SEWAGE DISPOSAL TESTING

Revised Percolation Certification Plan
 6717 Cortina Dr. Highland, MD 20777
 Tax Map: 34 Grid: 20 Parcel: 354
 William Taylor

DEED REF: 736 - 167
 LOCATION DRAWING OF #6717 CORTINA DRIVE LOT 10 BLOCK "C" SECT. THREE "GREEN HILL MANOR" P.B. 30 - 32 PARTS OF BLOCKS "B" "C" "D" & "E" HOWARD COUNTY, MD.
 DATE: 5/10/07 SCALE: 1" = 30' FILE:

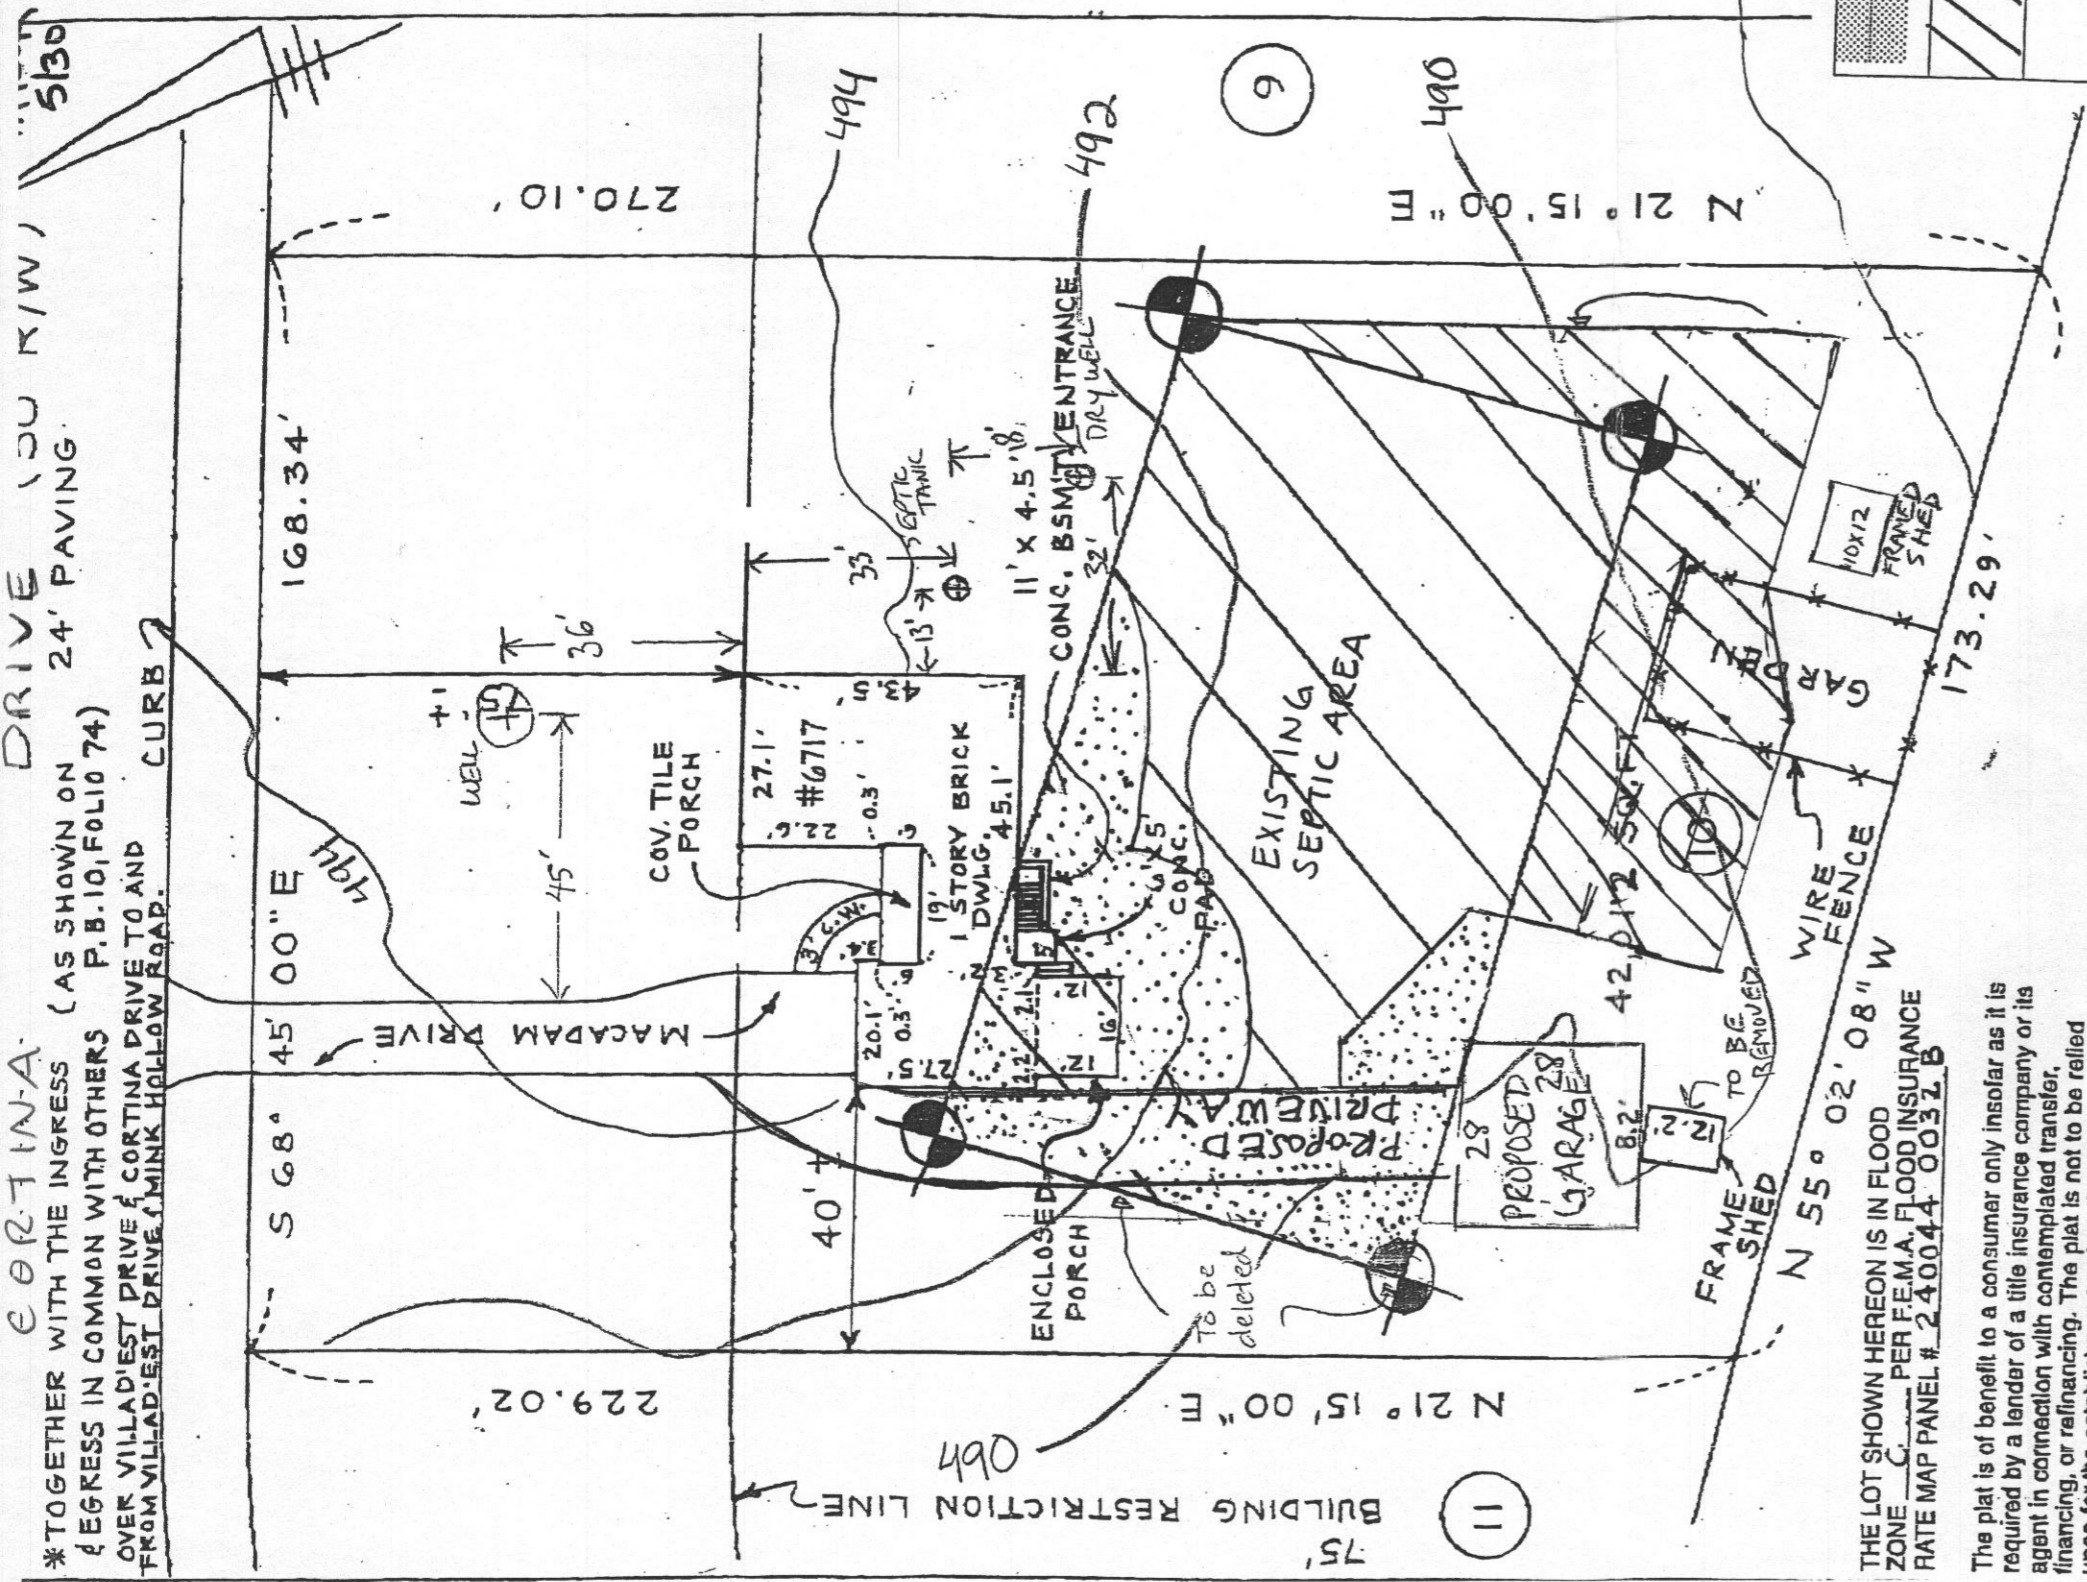
septic area to be deleted
	septic area to be added
	passed perc (9-13-73)

1. ANY CHANGES TO A PRIVATE SEWAGE EASEMENT SHALL REQUIRE A REVISED PERCOLATION CERTIFICATION PLAN.
2. THIS AREA DESIGNATES A PRIVATE SEWAGE EASEMENT OF AT LEAST 10,000 SQ. FT. AS REQUIRED BY THE MARYLAND DEPARTMENT OF ENVIRONMENT FOR INDIVIDUAL SEWAGE DISPOSAL. IMPROVEMENTS OF ANY NATURE IN THIS EASEMENT ARE RESTRICTED. THIS EASEMENT SHALL BECOME NULL AND VOID UPON CONNECTION TO A PUBLIC SEWAGE SYSTEM. THE COUNTY HEALTH OFFICER SHALL HAVE AUTHORITY TO GRANT ADJUSTMENTS TO THE PRIVATE SEWAGE EASEMENT. RECORDATION OF A REVISED SEWAGE EASEMENT SHALL NOT BE NECESSARY.
3. THE TOPOGRAPHY OF THIS PLAT IS FROM HOWARD COUNTY DATA AND IS VERIFIED TO ACCURATELY REPRESENT THE RELATIVE ELEVATION CHANGES ON THE SUBJECT PROPERTY.
4. THE PURPOSE OF THIS PLAN IS TO REVISE THE EXISTING SEPTIC EASEMENT IN ORDER TO MAINTAIN THE DRAINAGE...
